35/13-06KK 27 QUINCY ST  
Chevy Chase Village Historic District

**HISTORIC PRESERVATION COMMISSION STAFF REPORT**

**Address:** 27 Quincy Street, Chevy Chase      **Meeting Date:** 12/20/06  
**Resource:** Contributing Resource      **Report Date:** 12/13/06  
                  **Chevy Chase Village Historic District**  
**Review:** ~~Preliminary Consultation~~ <sup>HAWP</sup>      **Public Notice:** 12/06/06  
**Applicant:** Mr. and Mrs. Christopher Landau      **Tax Credit:** None  
                  (John Katinas, Architect)      **Staff:** Michele Oaks  
**Case Number:** 35/13-06KK

**Proposal:** Major additions to a contributing resource

PROPOSED  
**A-4**  
ROOF PLAN

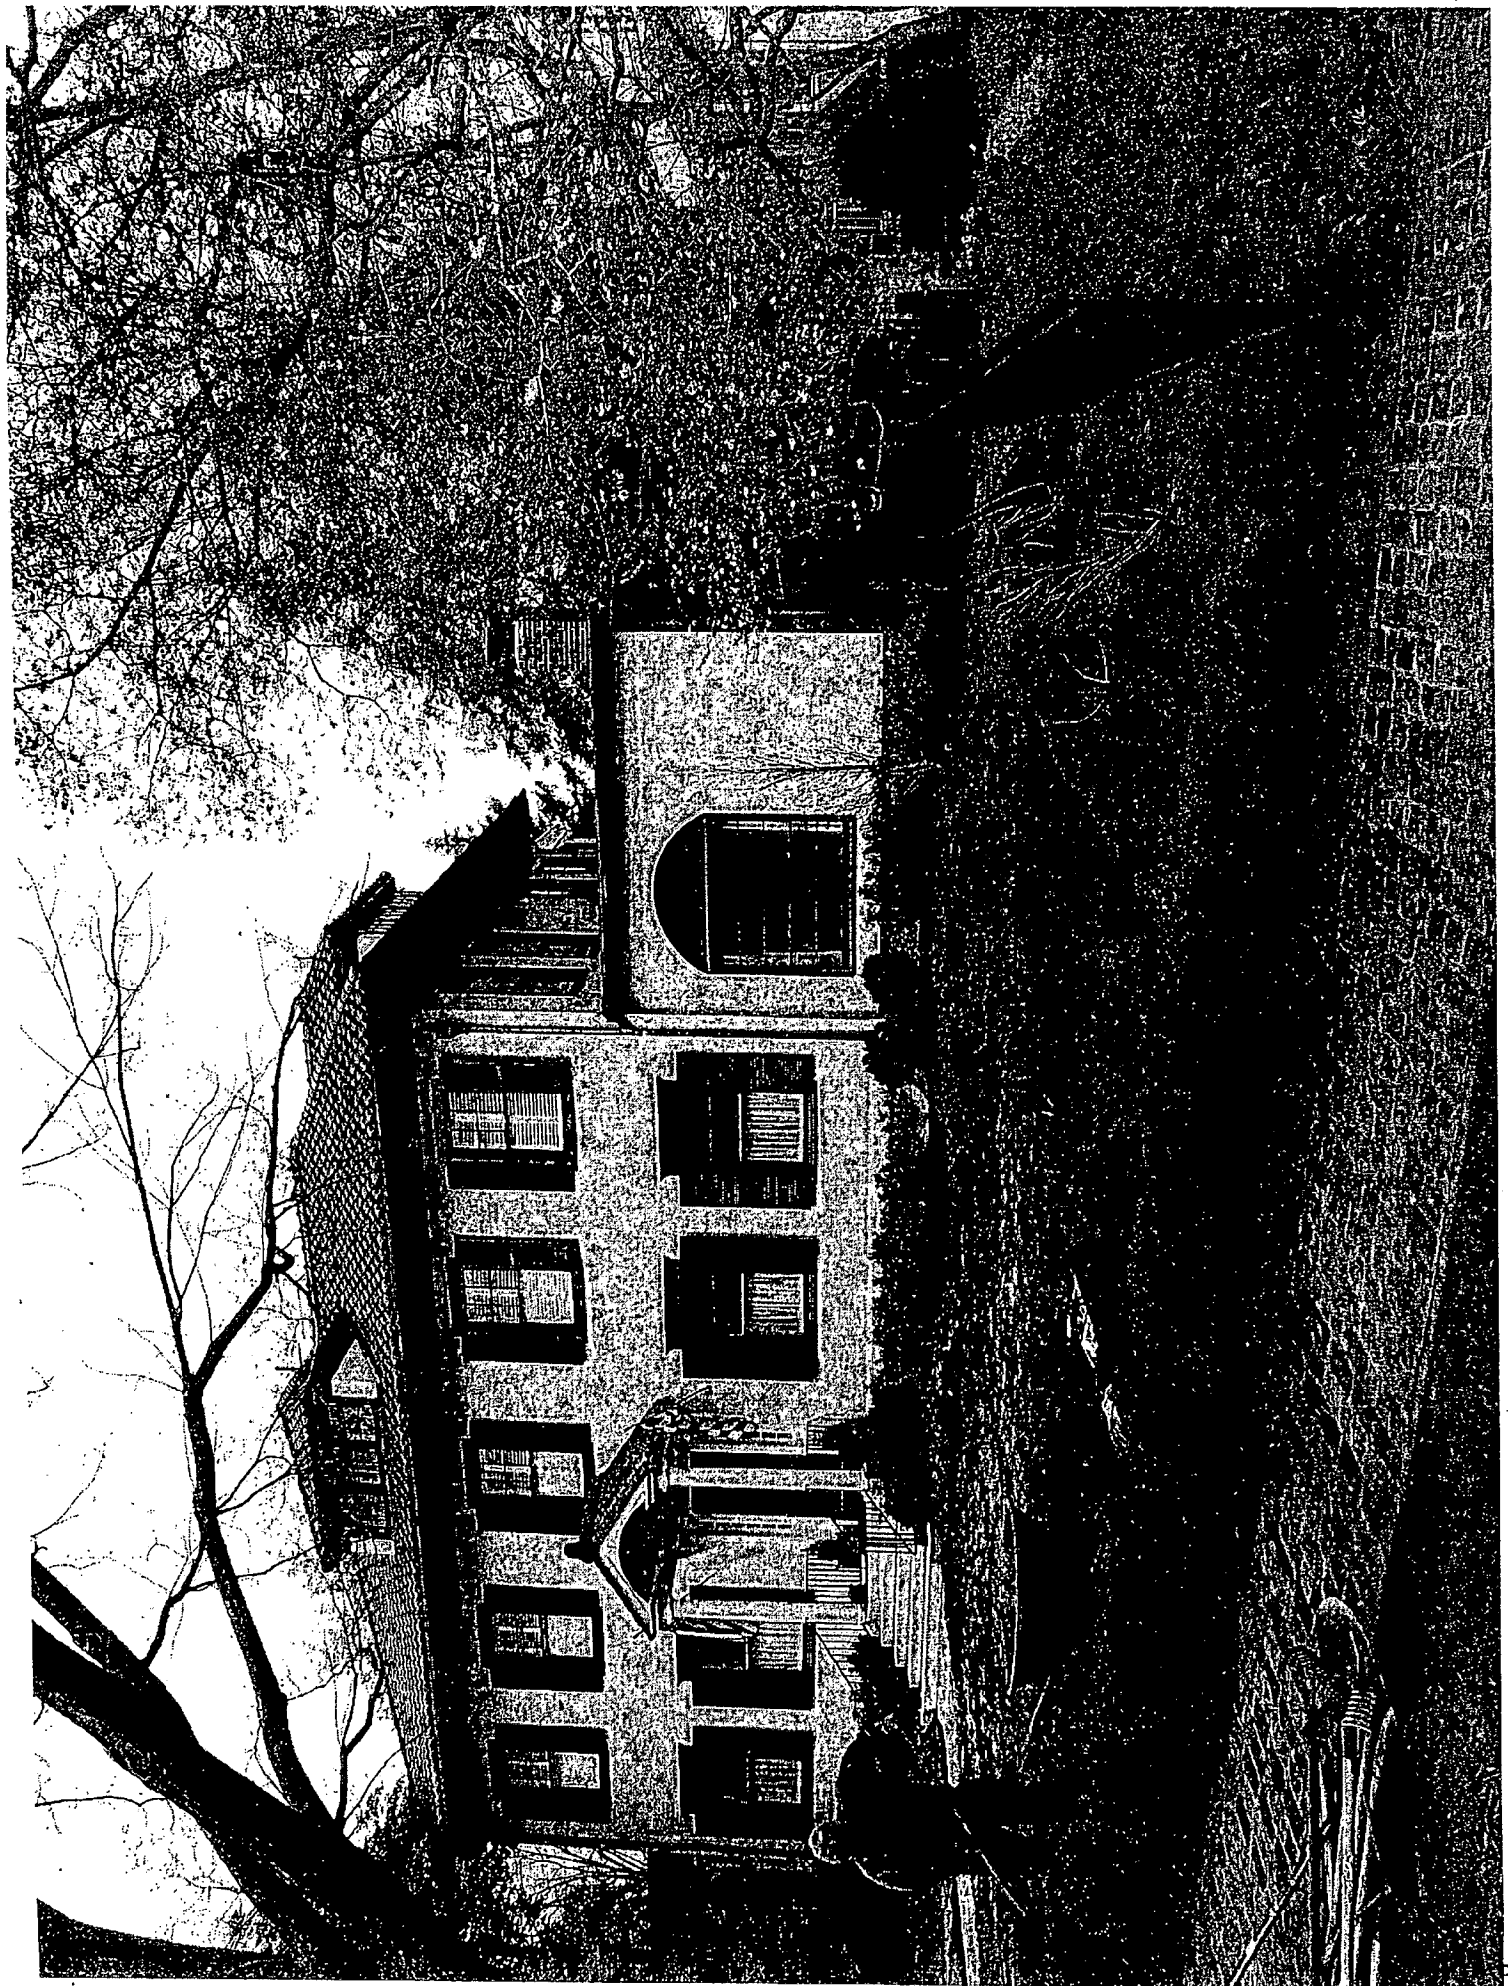
1 MS. O'MALLEY: I couldn't quite see it on the  
2 roof plan. Other commissioners feel the same way about some  
3 definition at the corners?

4 MR. DUFFY: I tend to agree that even though those  
5 corners are attaching to noncontributing or nonoriginal  
6 parts, I think it would be preferable to have an inset. It  
7 would be best to have the new not on the same plane as the  
8 existing. Overall, I think it's a good application or  
9 preliminary, but the roof at the back on the right side kind  
10 of bothers me. It does have a funny way of meeting the  
11 existing, and even though it won't be highly visible from  
12 the public right of way, it'll still be visible.

PROPOSED  
BAY MODIFICATION

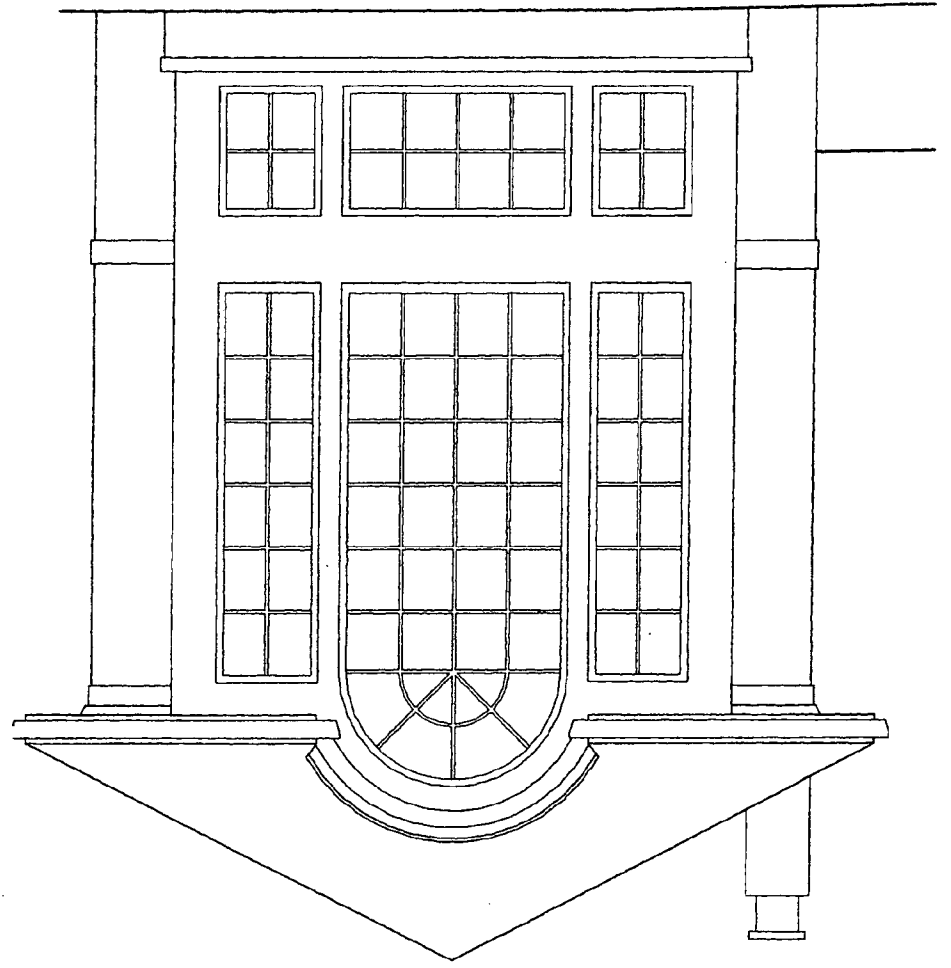
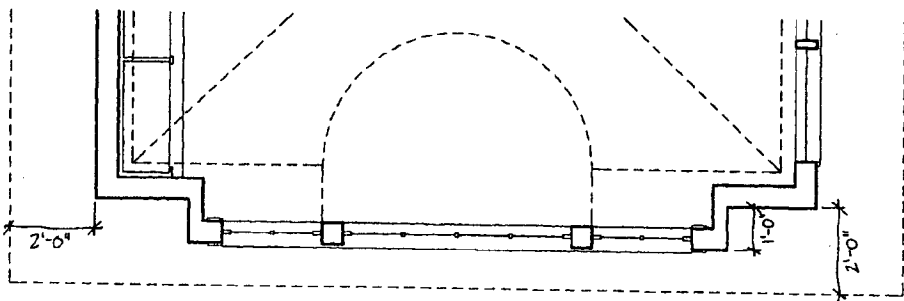
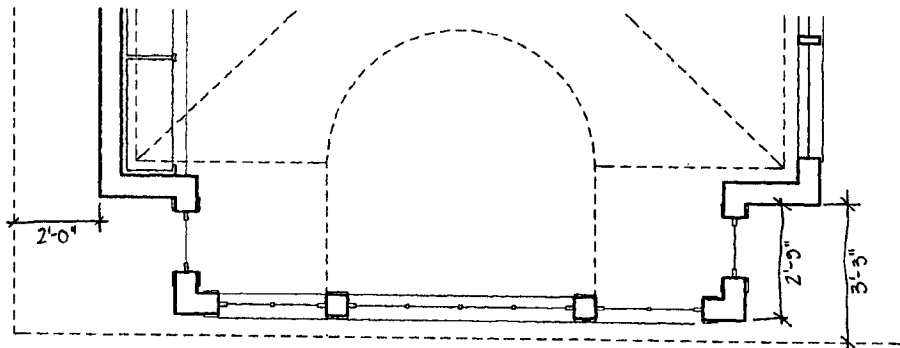
We have finalized a plan for the bay in the family room addition for the Landau residence at 27 Quincy Street. The modification deepens the bay shown in the current scheme and continues the projection in the basement bedroom below. We hope for your recommendation on how to proceed, seeing as we currently have an alteration in for historic approval, and this one is in addition to that change. I have attached a pdf file including the current scheme as well as the final scheme I described above. If there is more we can do, please let us know. Thank you.

*okd  
change  
on 12/15  
email  
response  
HPC app'd*

AS PERMITTED STAIR AND PATIO PLAN

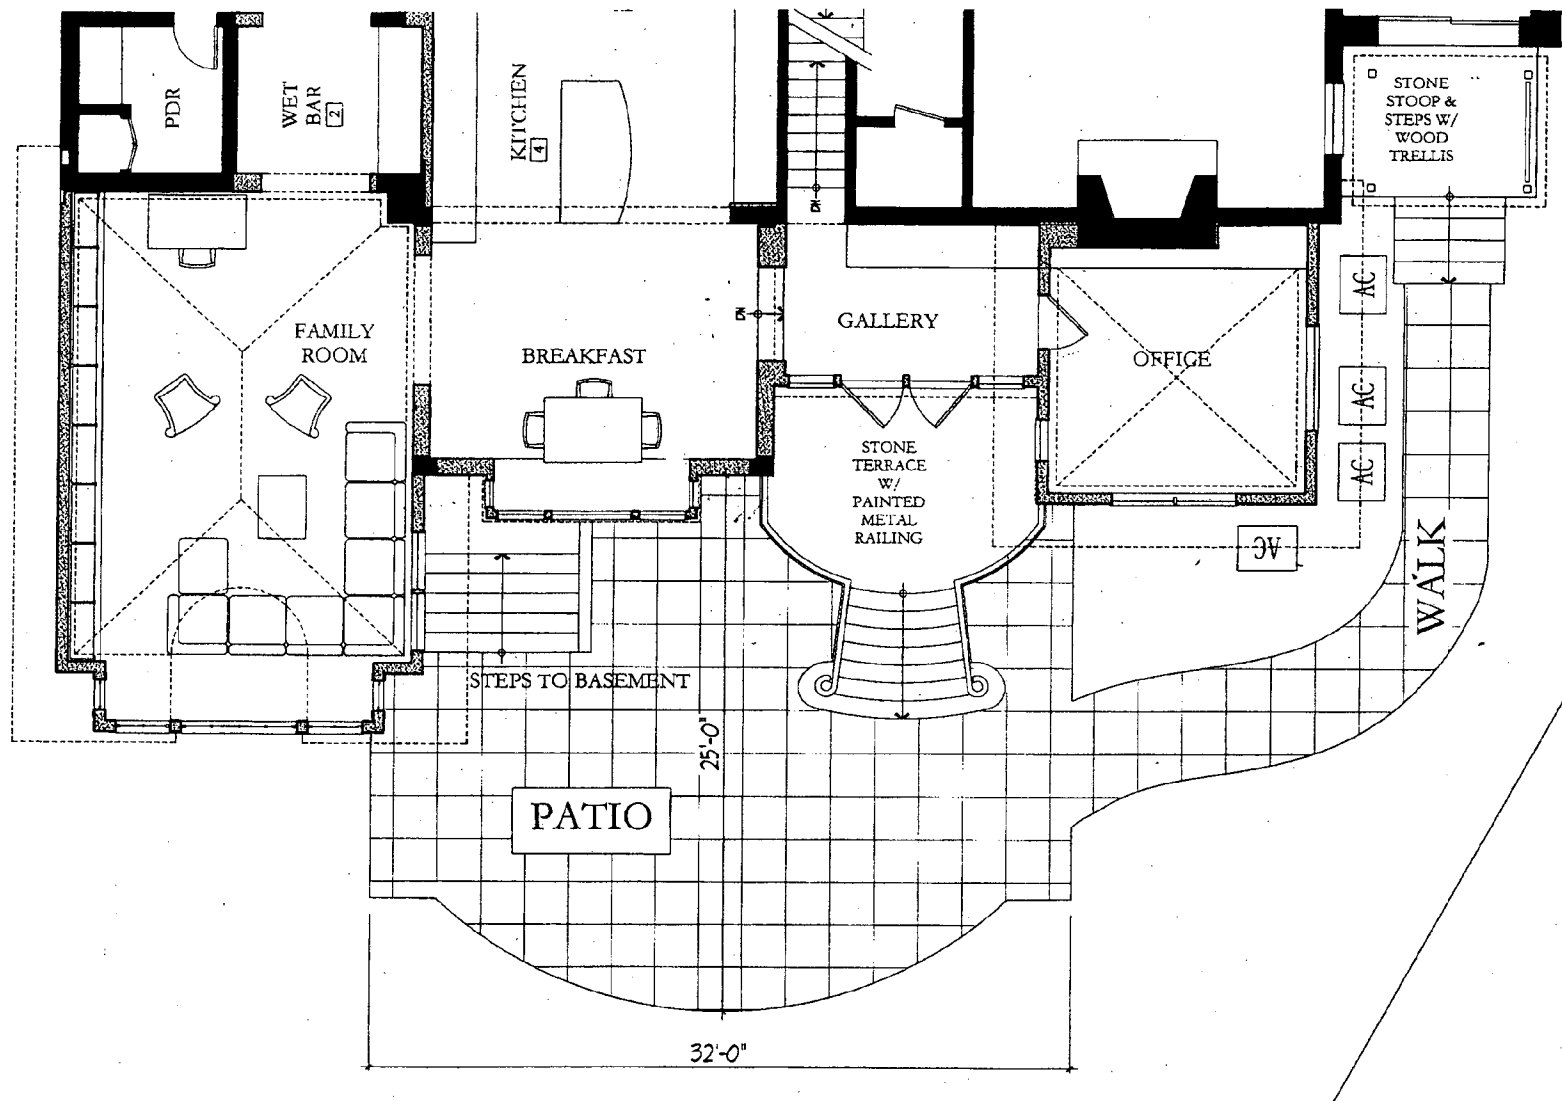
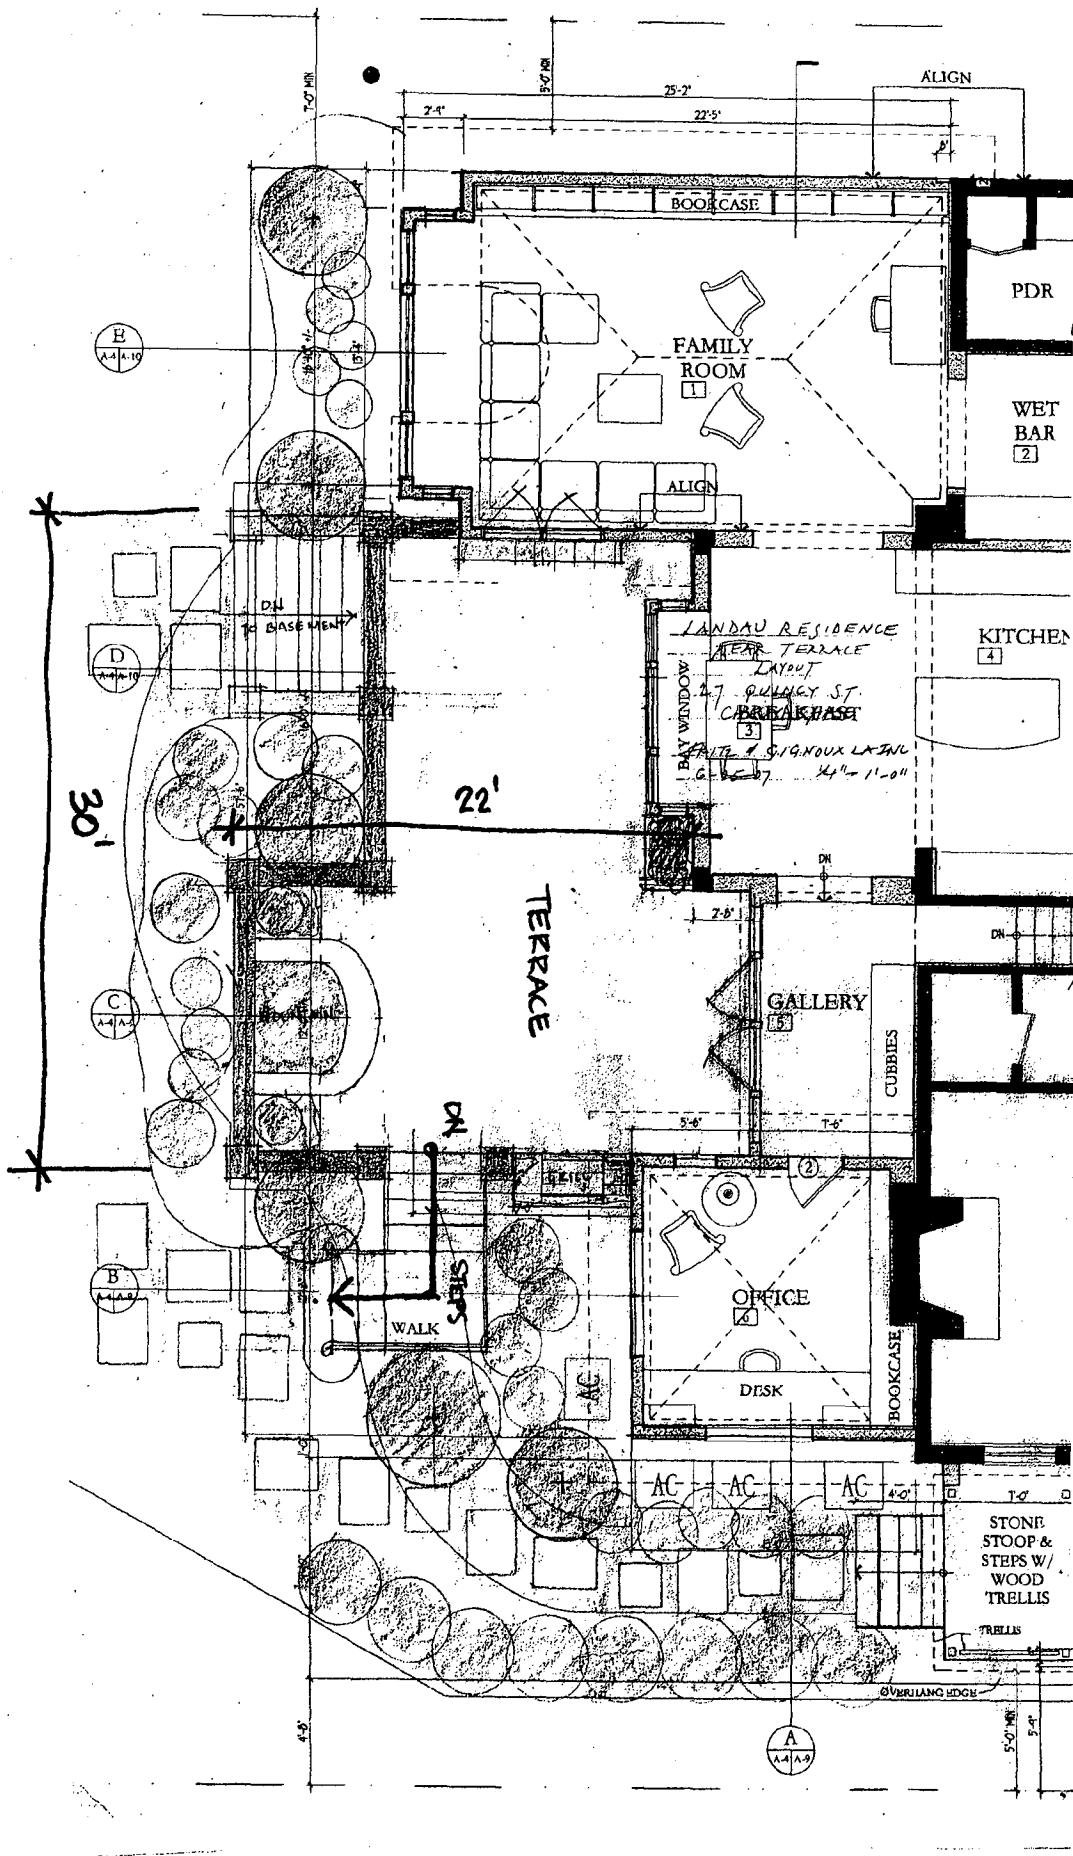
- Alterations to the configuration of the Terrace/Patio to be located at the rear of the property. Total width of the project will be reduced in size by 2' in width and 3' in length.
- Remove the solid walk leading from the side addition to the rear yard and replace it with stone "stepping stones".

Staff is recommending that the Commission support this design change as it decreases lot coverage and increases permeable surface and give the staff authority to approve these changes as these are considered minor alterations to the already approved design for the rear addition and landscape.
